155041.006.002

Subject: Response to Comments Letter, February 1, 2021
Notice of Intent
Former Aerovox Facility, RTN 4-0000601

Site Plans to Accompany Notice of Intent

Revised Drawings C-204, C-205, C-318 and C-320

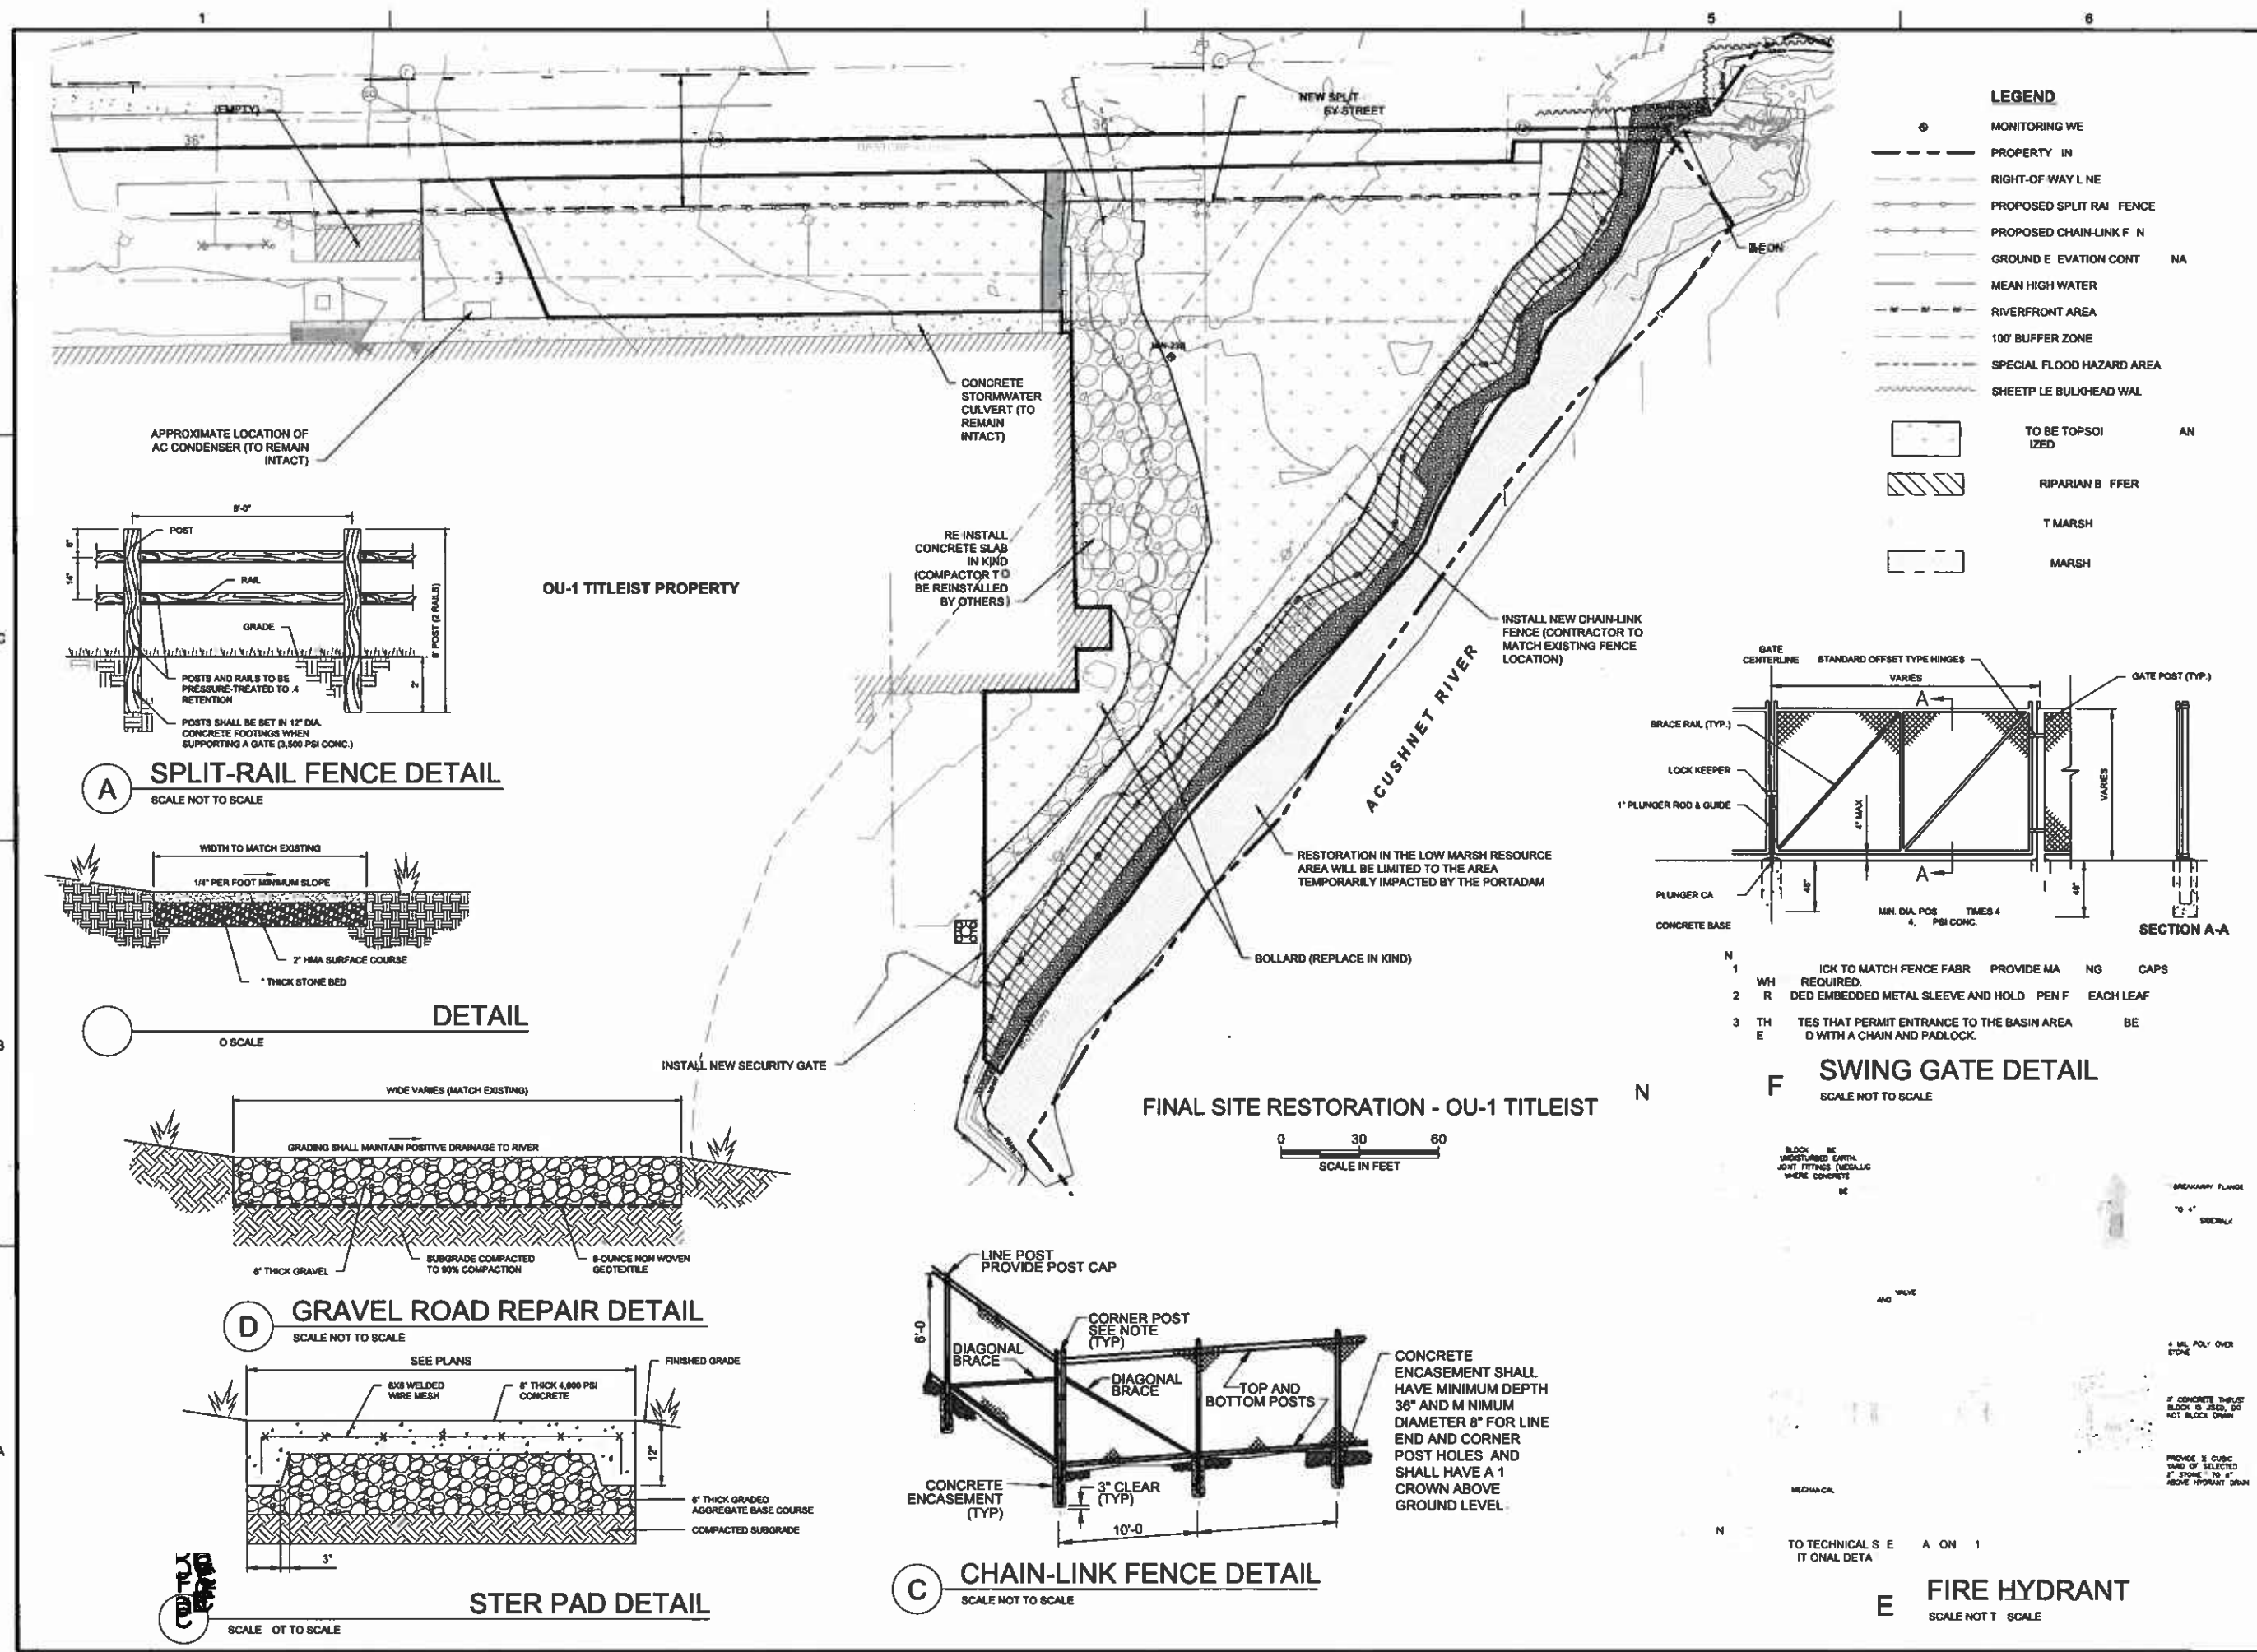
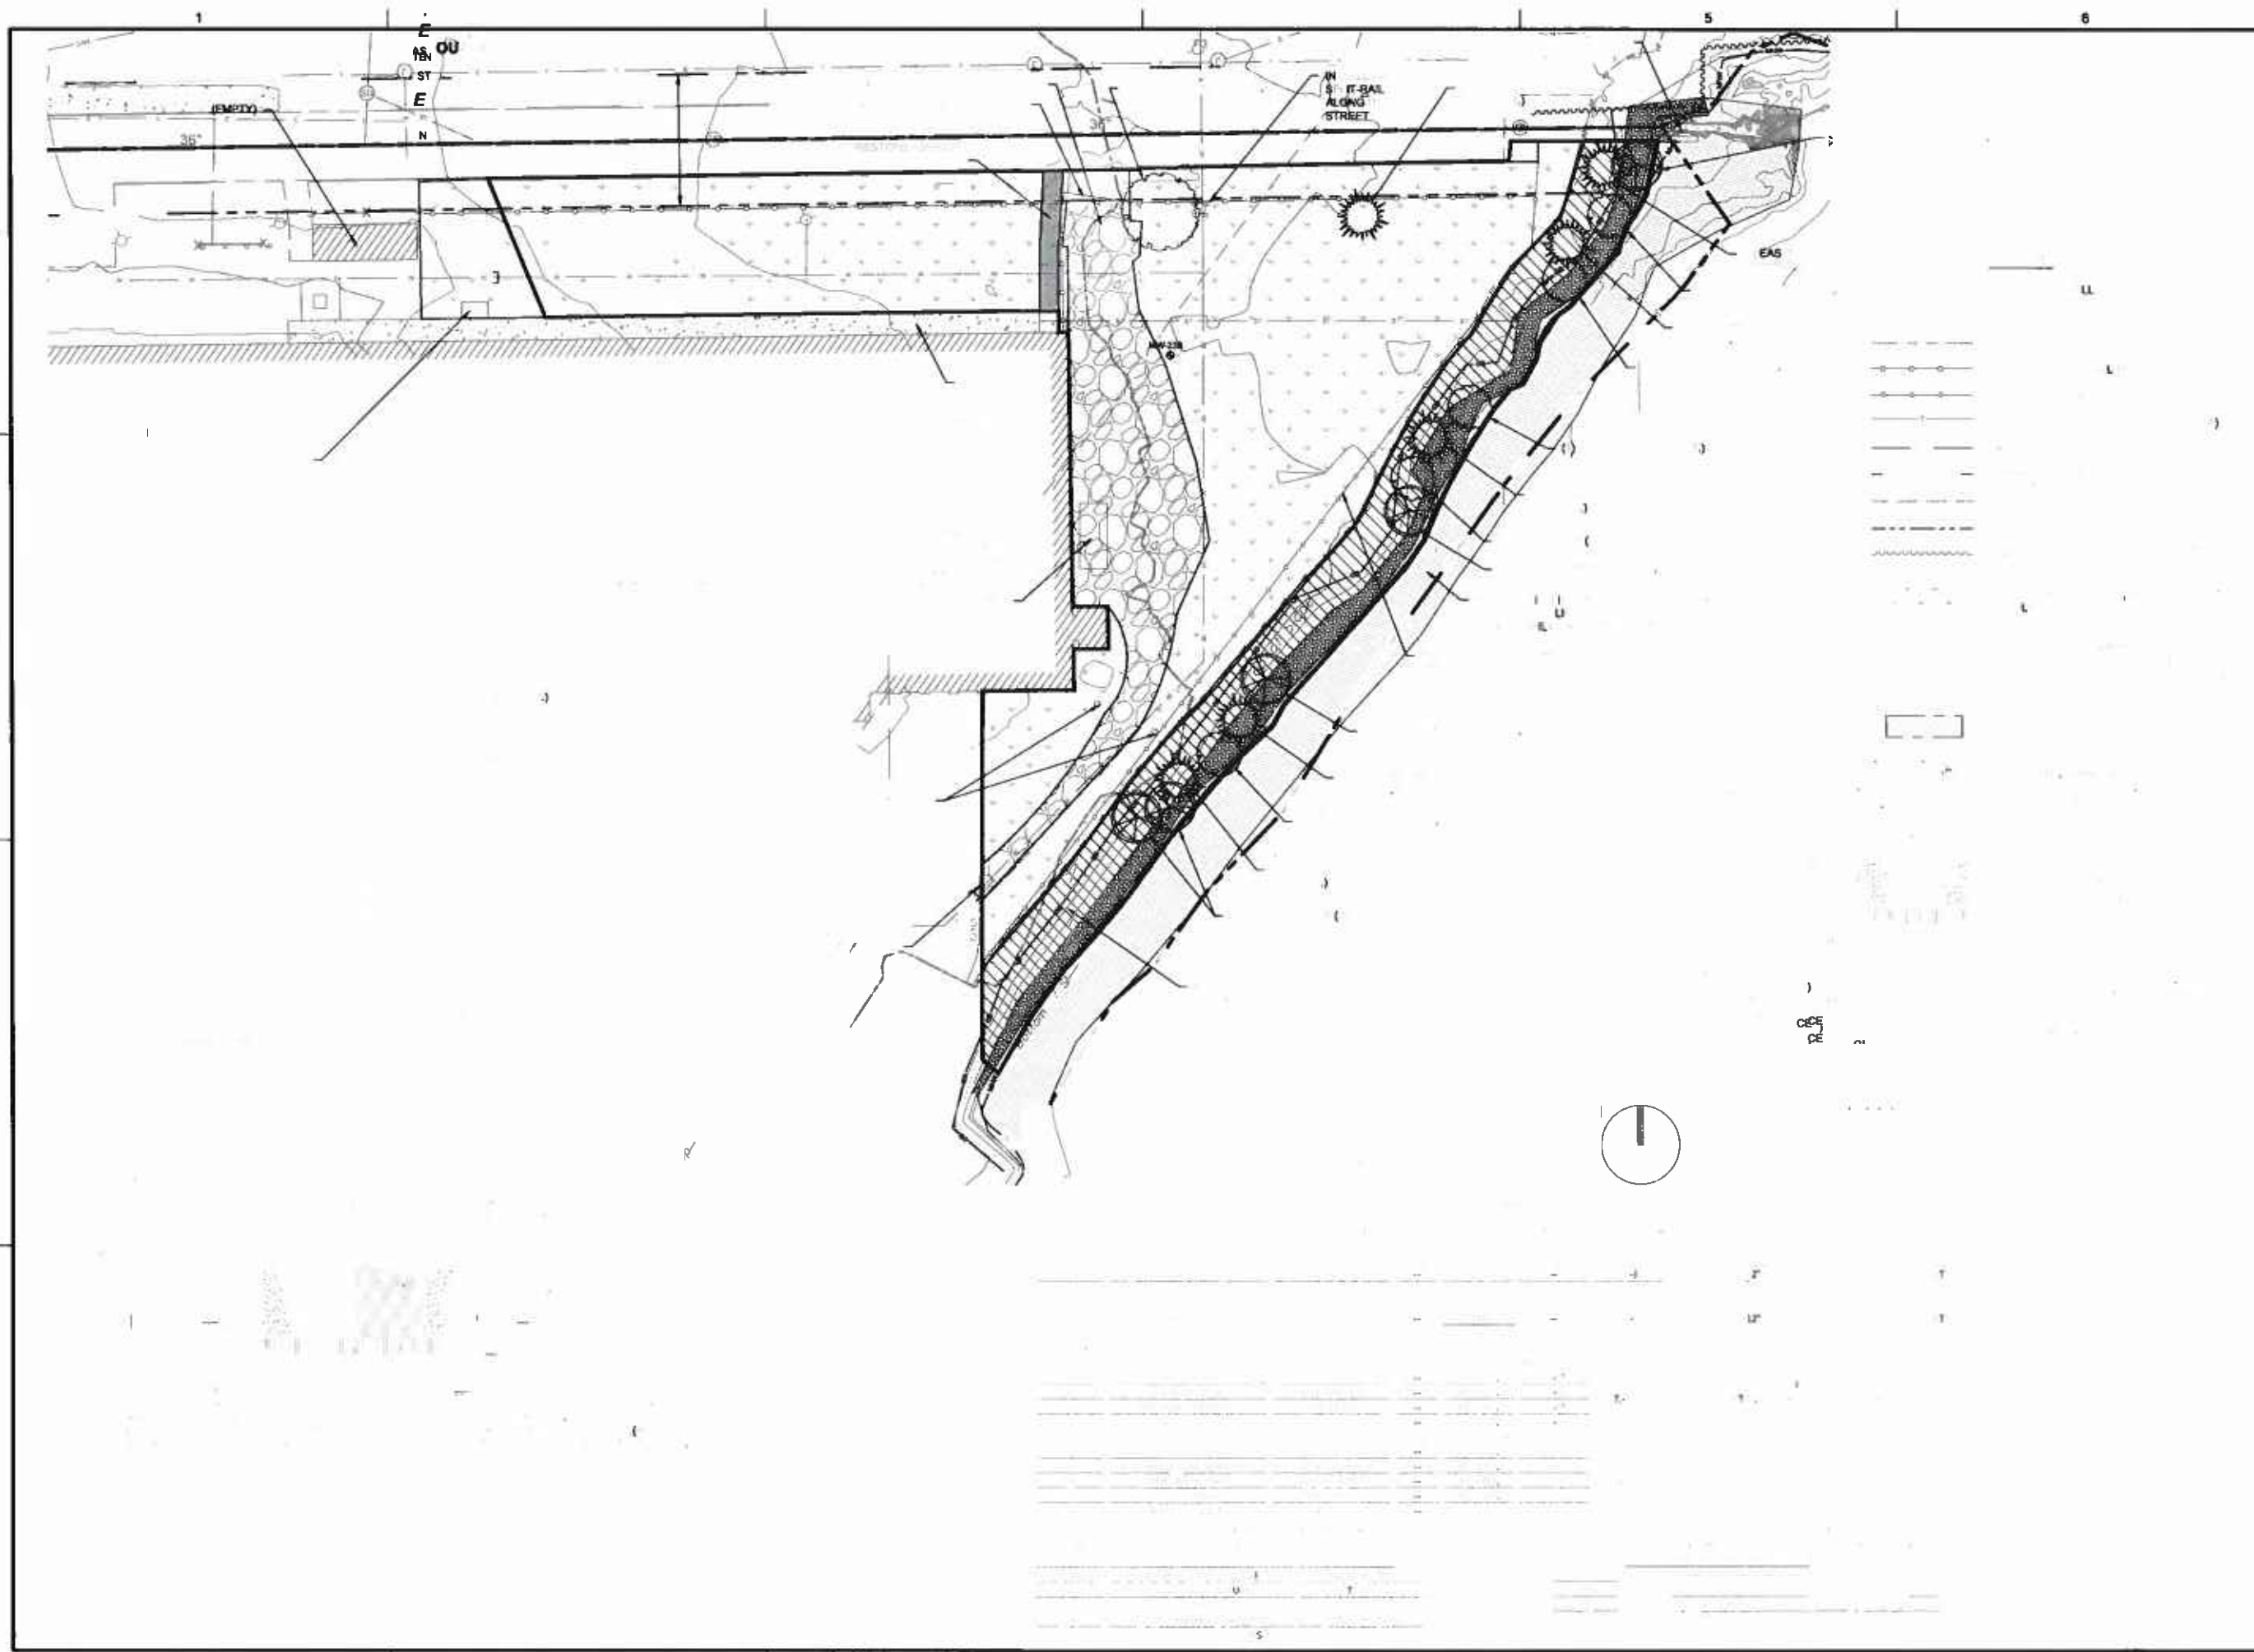
19. Comment: The final paragraph of Section 4.1 describes the salt marsh restoration work planned for the Titleist Property (OU-1). The description of the work describes planting both high and low marsh species, and briefly mentions the addition of sand fill. The narrative directs the reader to construction drawings C-318 through C-320 for additional plans and details regarding this work. Construction drawings C-318 through C-320 show the restoration work for the Aerovox Property (OU-3), not the Titleist Property. The restoration work for the Titleist Property is shown on

construction drawings C-204 and C-205. These plans, however, do not show any proposed salt marsh restoration work and do not indicate that any fill will be placed in the salt marsh.

41. Comment: *There is a significant area of existing salt marsh fronting that property [Titleist] that could be adversely affected by the proposed work, specifically due to the*

coffer dam and silt curtain placement (either because these components are placed with the salt marsh and will do direct damage or because they are placed seaward of the salt marsh and will indirectly adversely affect the marsh by cutting off its natural hydrology – the application narrative and site plans do not clearly articulate which will occur). Woods Hole Group strongly recommends that the Commission request a salt marsh restoration plan for this area.

Response: On the Titleist property, a small area of salt marsh that is located above the MHW line will be excavated to remove contaminated soil. Following contaminated soil removal, clean fill soil will be backfilled into the area above the MHW line to a minimum of 4 inches below final grades in areas of steeper slopes. The remaining 4 inches will consist of a sandy loam topsoil containing organic matter. In areas with slopes of 8H:1V or less, clean fill soil will be backfilled to a minimum of 12 inches below final grades and 12 inches of sand fill will be installed, similar to the marsh creation on the Aerovox Property. In these flatter areas where slope stability is of less concern, sand fill is a preferred media since it allows better drainage of the soils during tidal cycles, helping plant survival and quicker root growth for plant establishment. The sand is also not as easily carried away from the site, helping to hold established finished grades better. The small amount of fertilizer placed with each marsh plant plug helps provide the needed nutrients as recommend in the Virginia Institute of Marine Sciences living shoreline guidance documents. Using organic materials or topsoil materials with lower drainage characteristics in these flatter areas can result in poorer growth of the marsh plants. Over time, organics are deposited in the flatter tidal areas and provide the natural nutrients used by the plants. Detail drawing B, provided on Drawing C-320 shows a cross section of soil to be removed and placement of clean fill based on slope condition. Drawings C-204 and C-205 have been revised to show the salt marsh restoration in plan view.

Response: As noted in the response to Comment 19, Drawings C-204 and C-205 have been revised to show restoration of the salt marsh area. Also as noted above, when establishing marsh areas, using a coarse-grained sand provides quicker establishment of the marsh plants by allowing quicker root growth and better drainage of the material during tidal cycles in flatter areas. Over time, the soil medium will become more organic to sustain the marsh plants. See attached photos of similar representative plantings.

Response: Salt marsh restoration activities are depicted on revised Drawings C-204 and C-205. BC anticipates that a more detailed maintenance and monitoring plan associated with restoration activities will be a requirement of the Order of Conditions.

Revised Figure 2

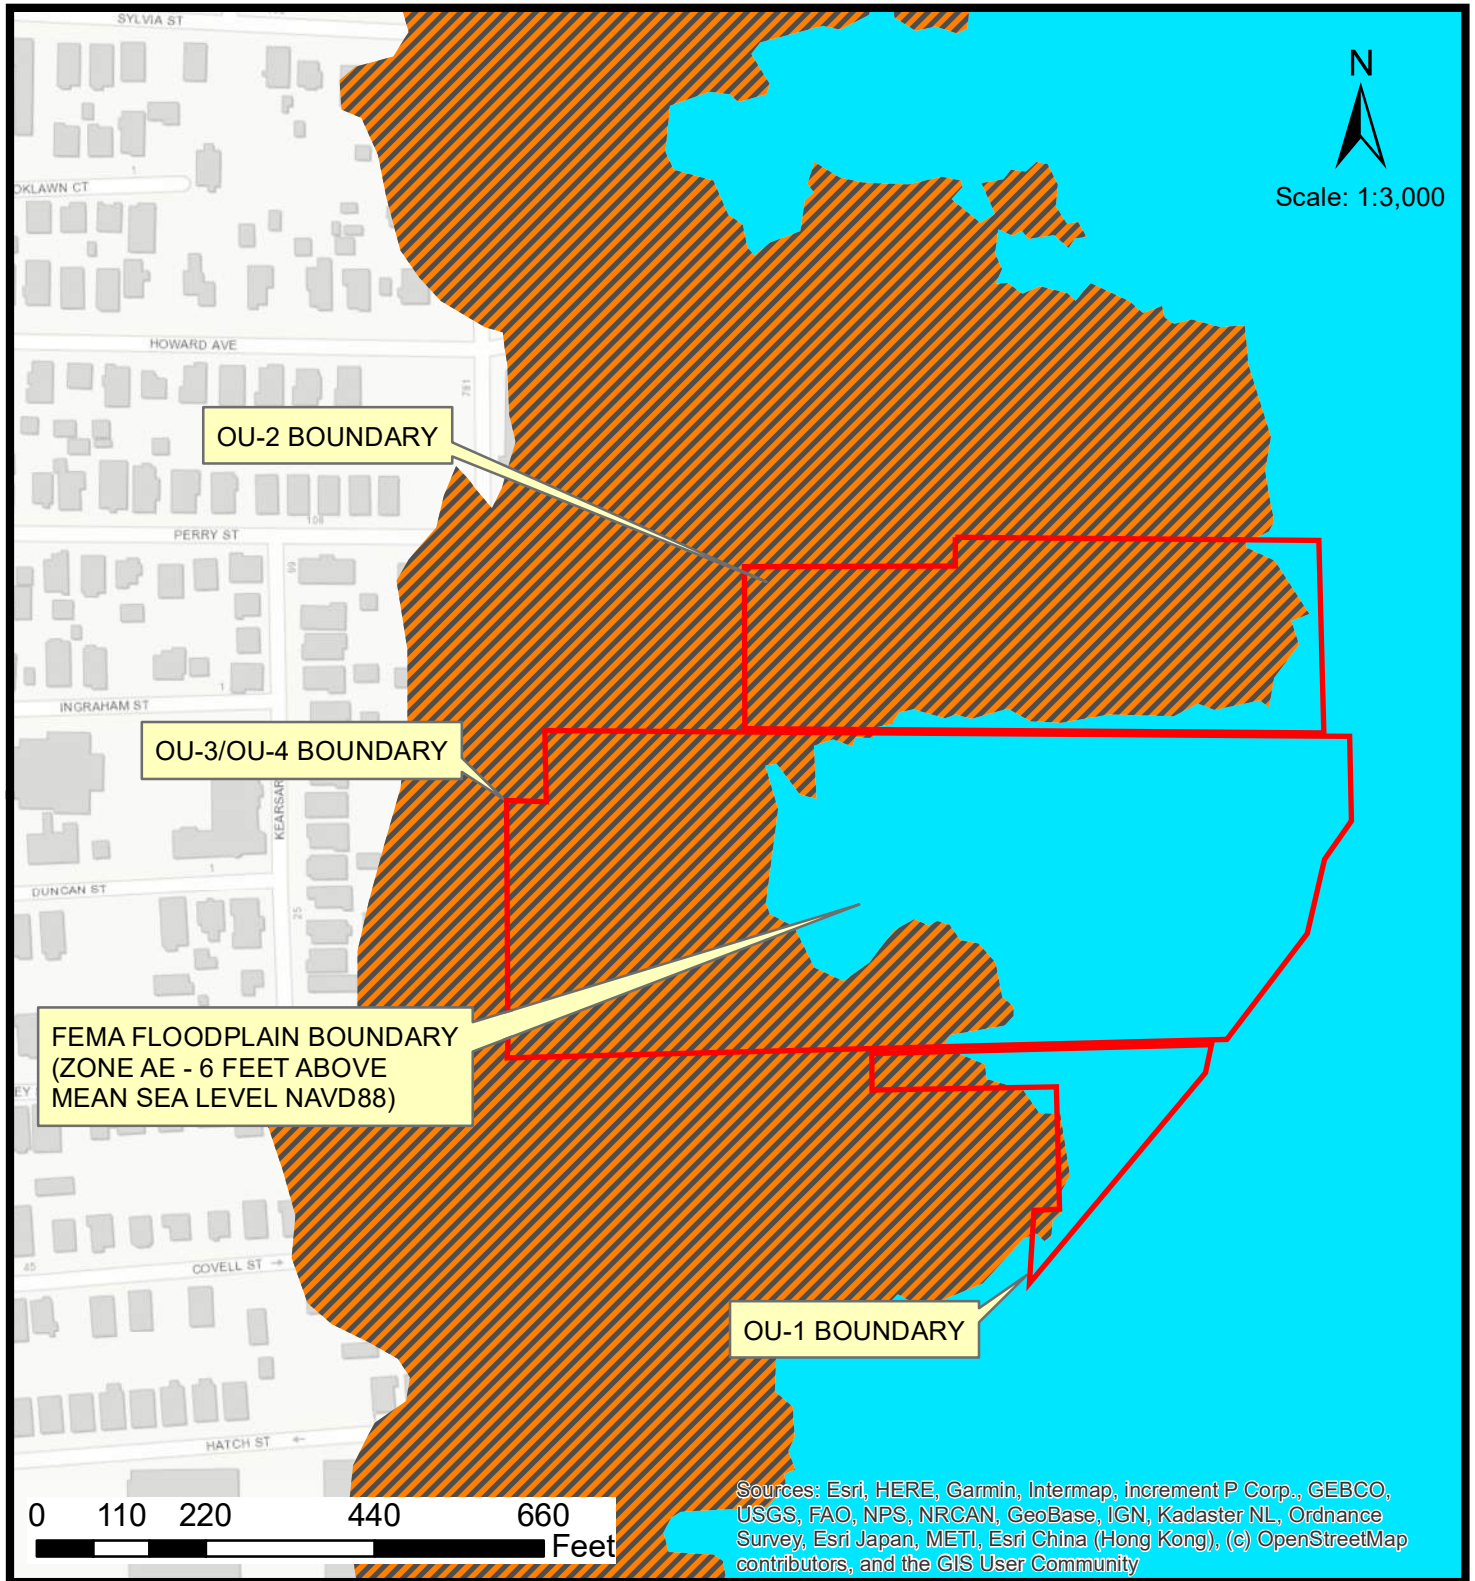
28. Comment: *Figure 2 presents a FEMA Flood Zone Map. The boundaries of the FEMA flood zones are depicted on the map, and the legend indicates whether particular*

areas or AE or X (0.2% Annual Chance of Flooding), for example, but the map does not show the base flood elevations (BFEs).

Response: Figure 2 has been revised to add the base flood elevations and is attached.
